Access Compliance Report

Public Rights-of-Way

(Pedestrian Signals)

Intersection ID: N/A	Main Street:	Cross Street: N/A	Location: N/A
ADA ID: FE0513F3A3C2	Signal Type: One Push Button-Non APS	Overall Compliance: No	Severity Score: BTN 1: N/A BTN 2: N/A No BTN: N/A
Codes/Mitigation Info/Possible Solution		Field Measurements/Component Compliance

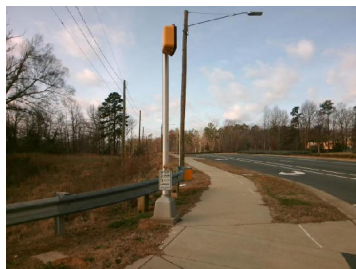
PROW/ADA: TMUTCD 4e.08, R404.2, R404.3, R404.7.2

N/A	B 1 Clear Xing Direction?	Yes	N/A	B 2 Clear Xing Direction?	N/A
	B 1 Crossing Direction	To NW		B 2 Crossing Direction	N/A
Yes	B 1 DistanceTo XWalk (in)	12.0	N/A	B 2 DistanceTo XWalk (in)	N/A
No	B 1 DistanceTo Curb (in)	132.0	N/A	B 2 DistanceTo Curb (in)	N/A
Yes	B 1 Diameter (in)	2.0	N/A	B 2 Diameter (in)	N/A

Possible Solutions: Replace Signal Push Button With APS Button on New Post. Remove & Relocate Sign.
